REGULAR MEETING OF THE DESIGN REVIEW BOARD OF THE TOWN OF JEROME 600 CLARK STREET 600 CLARK STREET, JEROME, ARIZONA

TUESDAY, SEPTEMBER 24, 2024, AT 6:00 PM

Zoning Administrator Analysis Design Review Board Tuesday, September 24, 2024

Zoning Administrator Analysis Design Review Board Tuesday, September 24th 2024

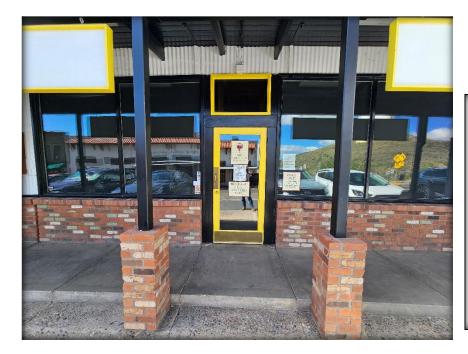
Response: The removal of one sign surface and addition of one facing a new direction will not increase the signage area beyond the allowable maximum square footage.

Response: The mounting locations for the signage already exists in place, and was used prior to the Pandemic for "Grapes". The proposed signage includes reusing these two existing signs (Each measuring 20" x 108", or 1.6' x 9', or 14.4 sq. ft. each) as well as the name "Haunted Pizano" applied to the entrance along with the hours of operation. Note that the hours of operation and locational information as well as service information are not counted in the total square footage of the sign. Each hanging sign is under the required 16 sq. ft. maximum size and together total to 28.8 sq. ft. of hanging signage, well under the maximum signage area of 32sq. ft.

Proposed Signage locations. Note that the Yellow trim around the border of the signs will be changed to red, while the interior of the sign board will change to black with white lettering. The above image has aa faint graphic on the four window locations, however the applicant has removed that as the total square footage of the signage would exceed the 32sq. ft. allowed.

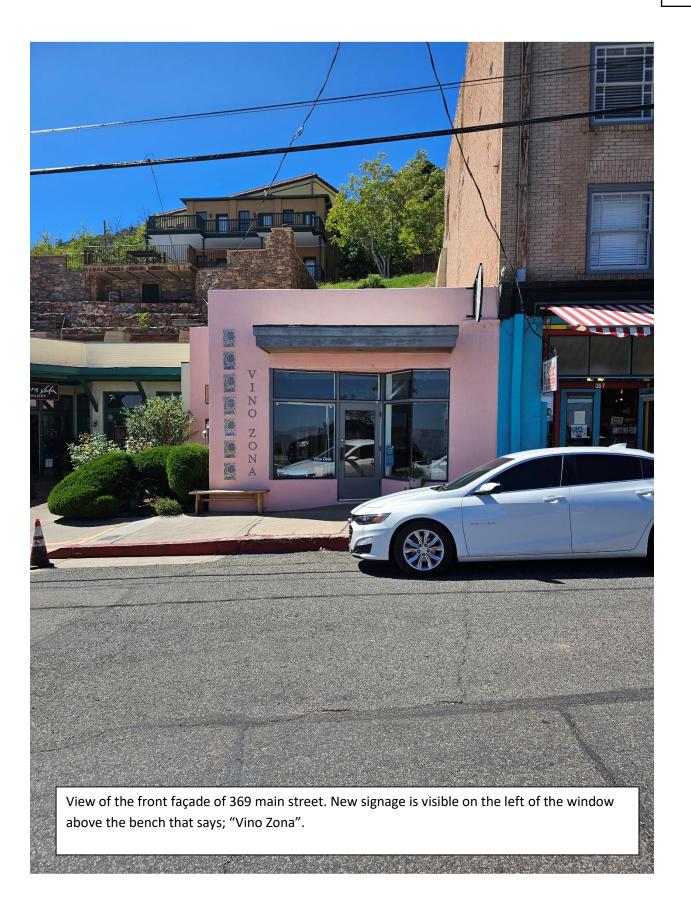
Background and Summary: The applicant has moved her business, Vino Zona, from 527 Main street to 369 Main street, and requires approval for signage on the façade of the new building. The double-sided hanging sign has been previously approved, as well as the mountain location and hardware on the building which is being reused. This sign meets all requirements from section 509 of the Jerome Zoning Ordinance. The new signage requiring review is the name of the business "Vino Zona" which was painted/stenciled onto the wall of the façade adjacent to easternmost window. The lettering is painted to match the existing tiles, with each letter 6.5" x 6.5" for a sign total of 6.5"x 7.1', for a total of around 3.5sq. ft of signage, well within the maximum sign area of 32sq. ft.

Response: The proposed new sign calculates to 3.5 Square feet roughly, well within the zoning ordinance requirements, as shown by the exhibit on the following page. The total allowable area of all signs on the building in the commercial zone is 32 square feet. The addition of this sign to the existing signage does not exceed the total allowable area for signage.

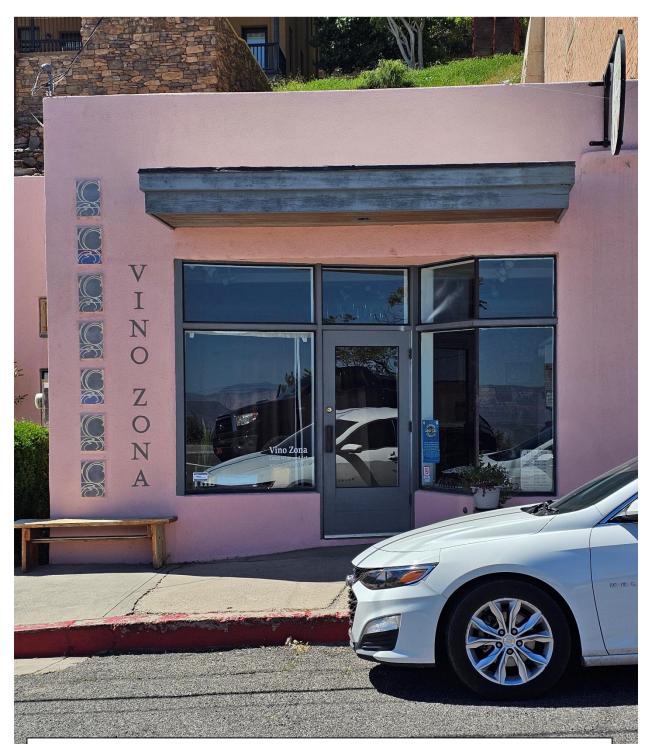
Closer view of the façade of 369 Main street showing the new signage on the wall in between the tiles and the window. The coloring of the lettering on the signage was chosen to match the grey of the tiles adjacent to the sign. The height of the sign is 7.1' which roughly matches the height of the window to the sign's right.
